P&Z STAFF REPORT

Board of Appeals Meeting, February 11, 2020

Cases: **V20-0004 – 148 West Belle Isle Road**
Staff Contact: Louisa Tovar (ltovar@sandyspringsga.gov)
Report Date: February 4, 2020

EXHIBIT A

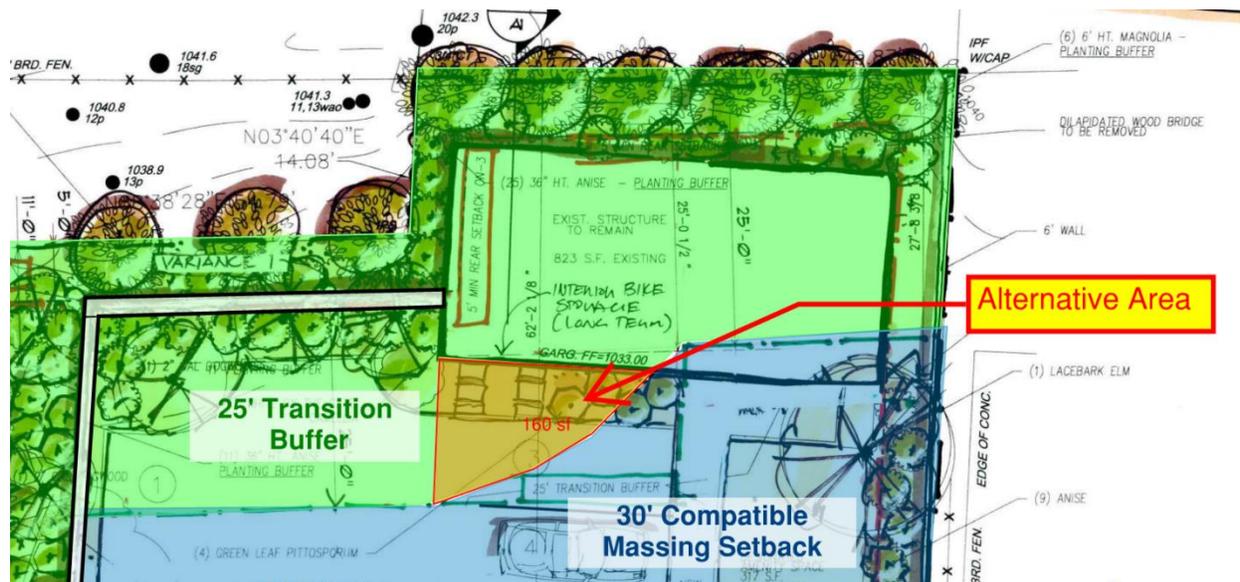
4. Encroachment into only the alternative area of the Protected Neighborhood Transition Buffer described as the portion of the property within 25 feet of the rear property line that is also south and east of the western side of the accessory structure (provided in this staff report as Exhibit A).

1 SITE PLAN
 SCALE: 1"=10'-0"

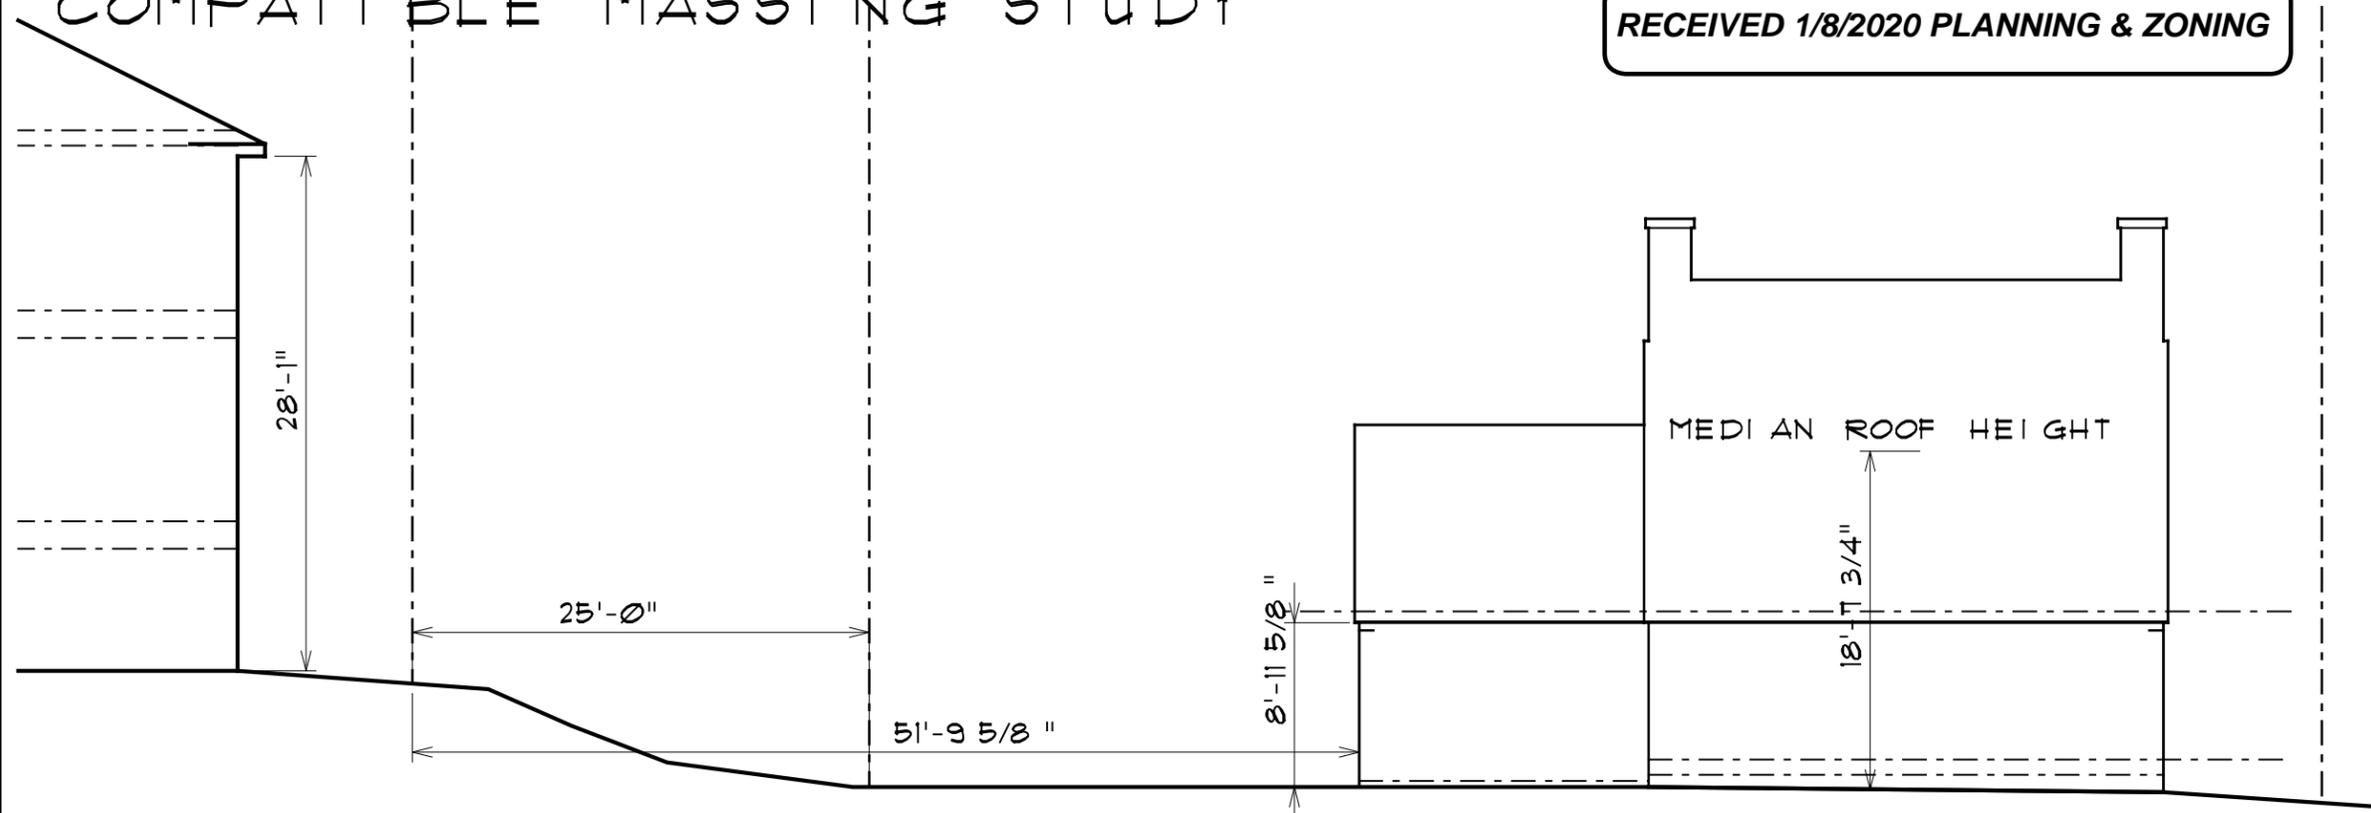
The site plan submitted with the application does not address stormwater management, site engineering, or traffic requirements. Those items will be reviewed for compliance at the time of LDP submittal.

Public Works supports frontage improvements, as required by Code (six (6)-foot sidewalk, two (2)-foot landscape buffer). The sidewalk should connect to the existing sidewalk on the adjacent parcel to the left of the site.

Vegetation within the right of way should not impede line of sight at the driveway.

Per Section 3 of the Code, the driveway cross slope shall not exceed two (2) percent in area where sidewalk is present or planned to be installed.

2 PROPOSED WEST ELEVATION
A2 SCALE: 1/8"=1'-0"

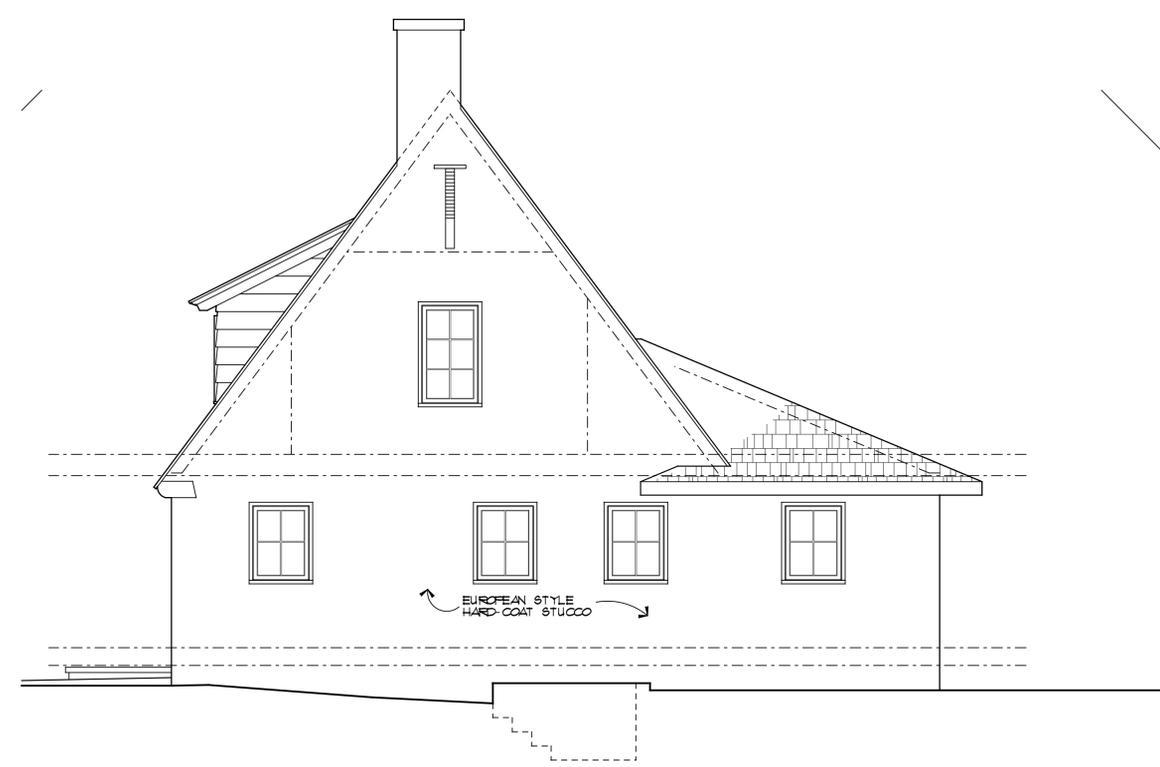
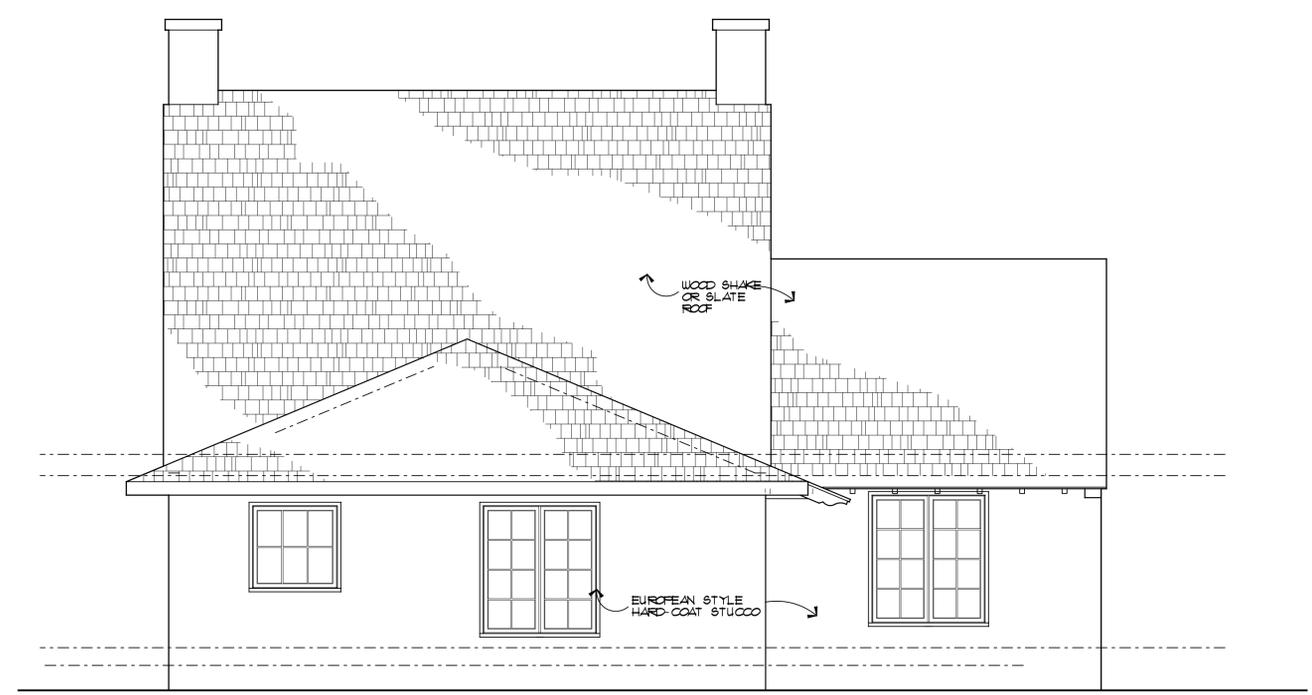
Variance #3, This provision is aimed primarily at new construction. Applying it literally to this condition ...would ...result in an ill-proportioned appearance to the building that would be antithetical to the goals of the Development Code.

Variance #4 is similar in nature to Variance #3. This provision is also aimed at new construction and, primarily, larger-scale mixed use development. Applying it literally to a small addition to an existing small-scale structure of residential character would also result in an ungainly, ill-proportioned structure that would be antithetical to the goals of the Development Code.

1. To the “*Proposed West Elevation*,” “*Proposed Front Elevation*,” and “*Exist Rear Elevation*,” prepared by Greg Busch, Architects A.I.A., signed and sealed by Greg Busch, R.A., dated June 4, 2019, received January 8, 2020.
